PROPOSED ROL - STAGE 1
 LOT 2 & 3 ON RP56826, LOT 2 & 4 ON RP118570 & LOT 1 RP51147
 Glennie Street, Drayton

TOOWOOMBA REGIONAL COUNCIL
 APPROVED PLAN
 referred to in Council's Decision Notice dated
6 February 2026
 This plan is subject to conditions of Approval Number
RAL/2025/4731
E. Hutchings
 Assessment Manager

CONCEPT PLAN - COMBINED SERVICES

PROJECT
71 LOT SUBDIVISION
2-22 DEVONSHIRE STREET
DRAYTON QLD 4350

TITLE
CONCEPT PLAN - COMBINED SERVICES

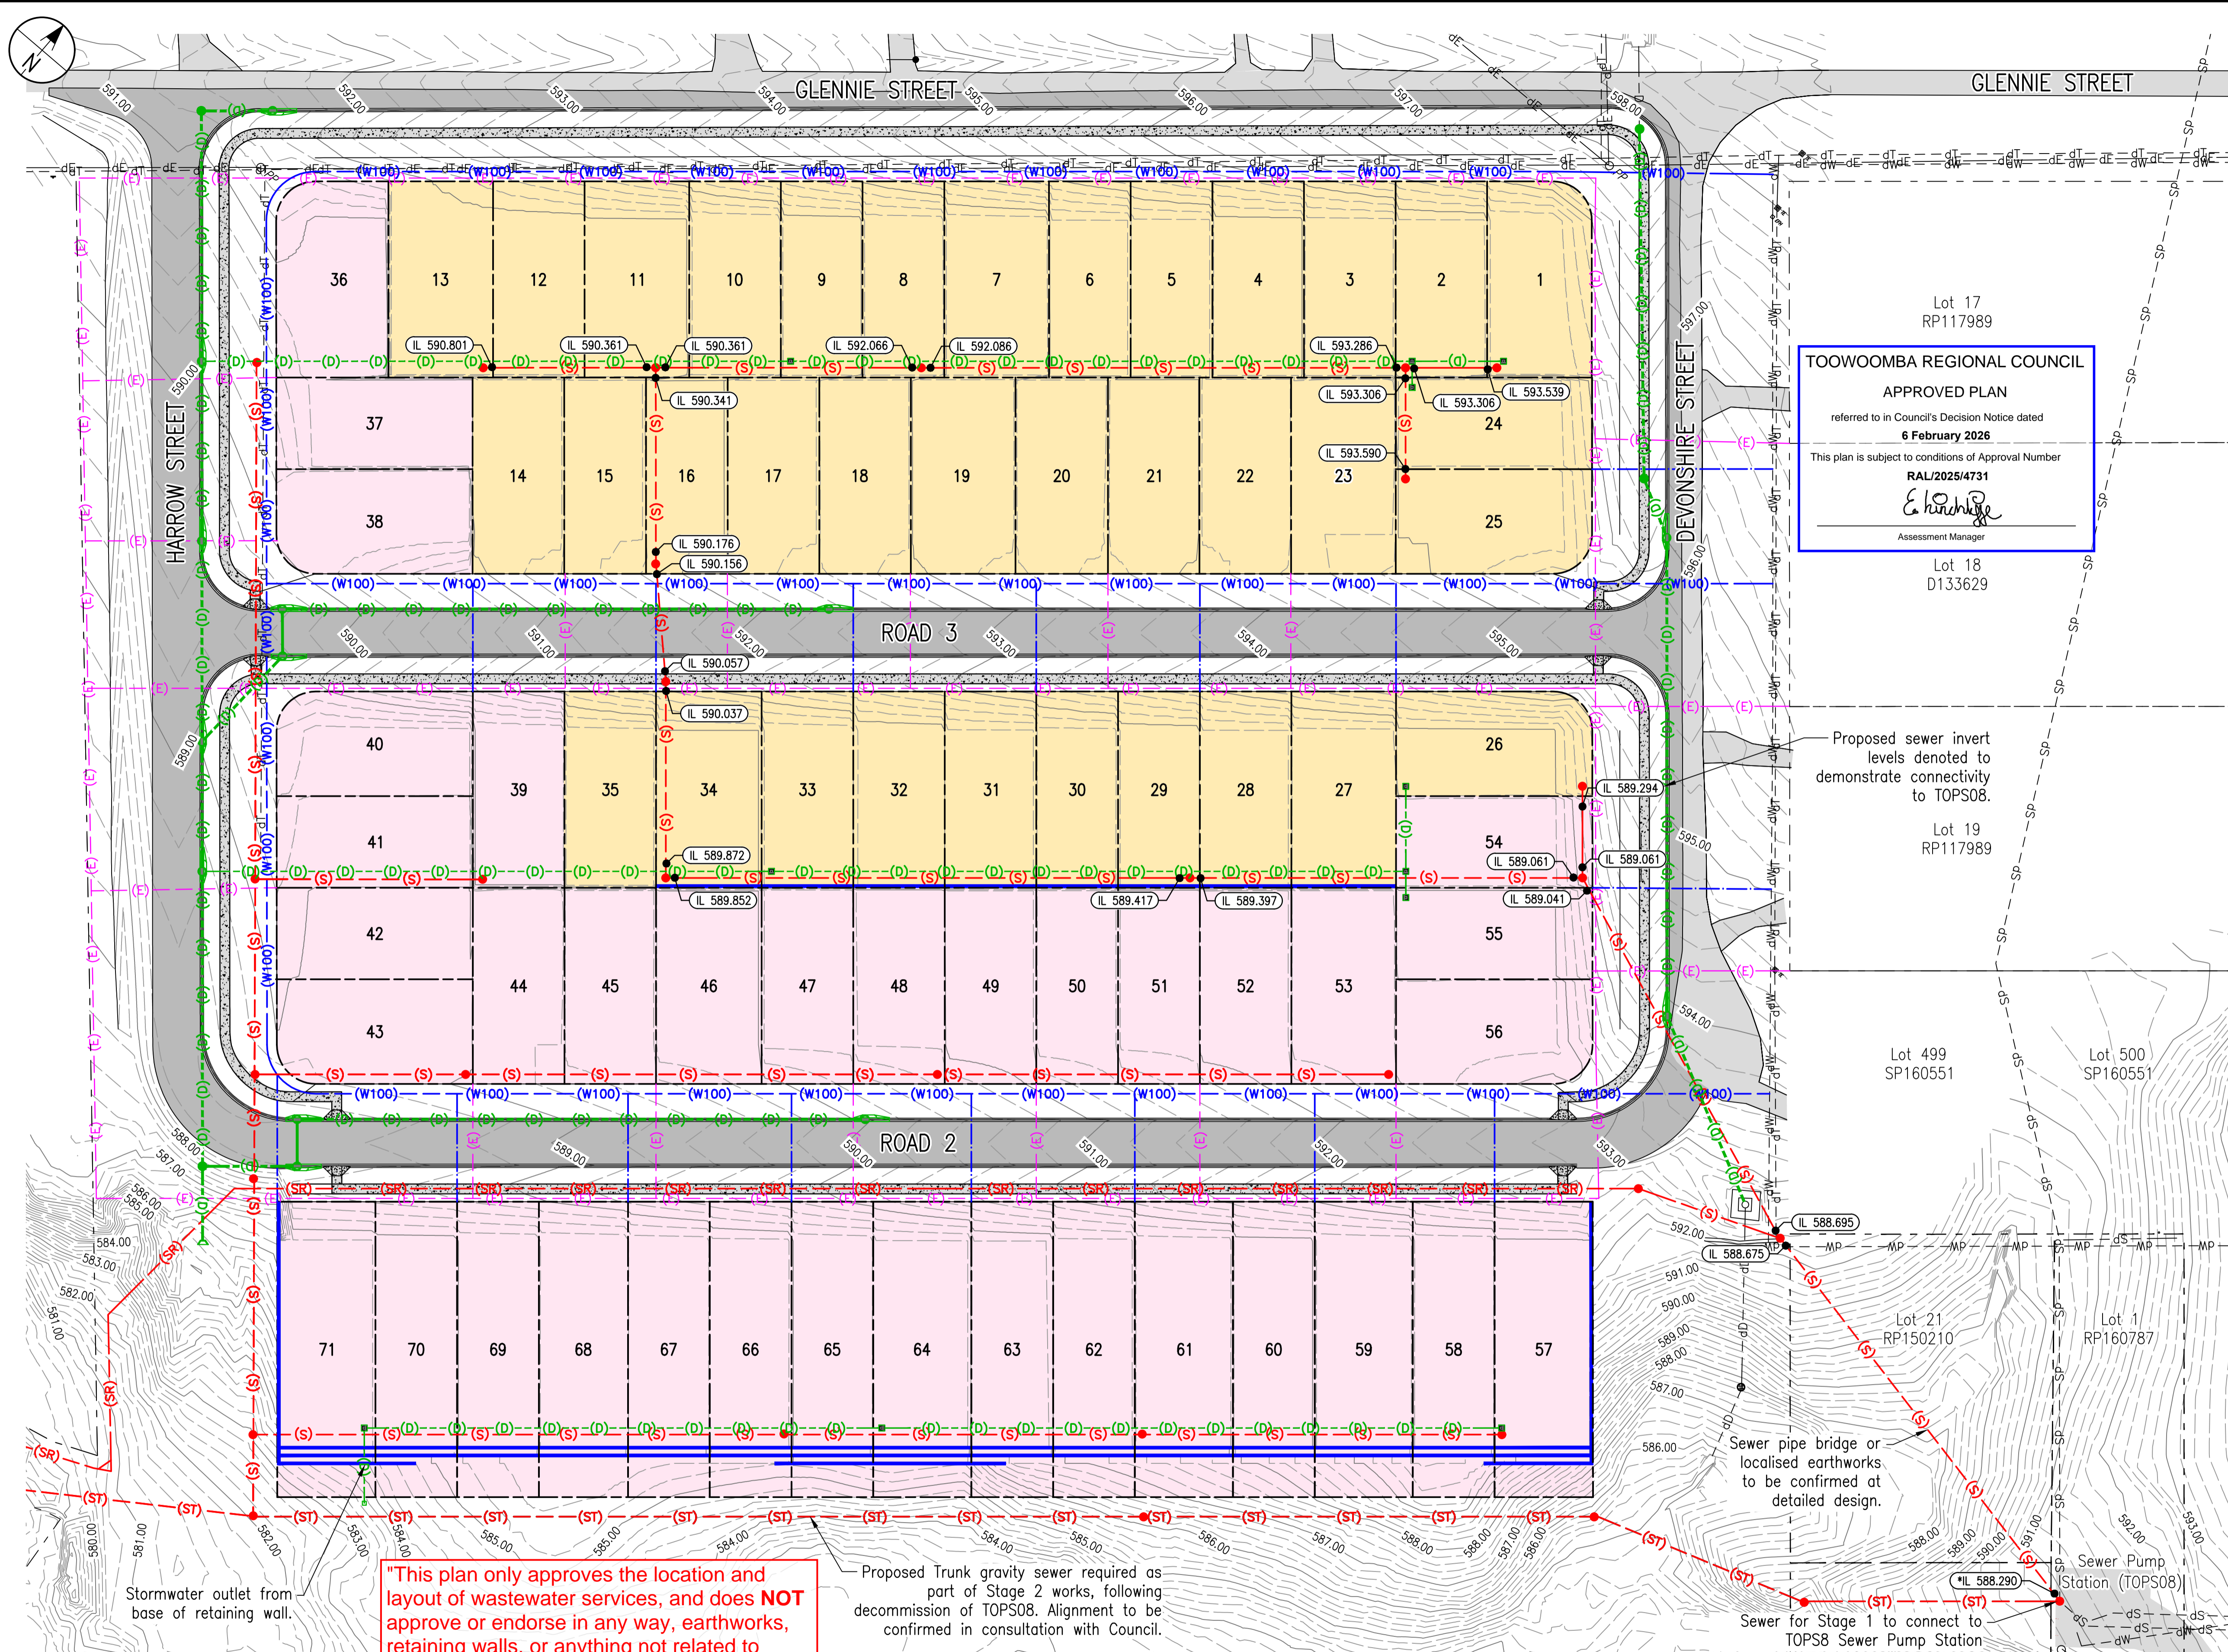
C.1. This plan has been supplied for information purposes only.

"This plan only approves the location and layout of wastewater services, and does NOT approve or endorse in any way, earthworks, retaining walls, or anything not related to wastewater infrastructure."

Proposed Trunk gravity sewer required as part of Stage 2 works, following decommission of TOPS08. Alignment to be confirmed in consultation with Council.
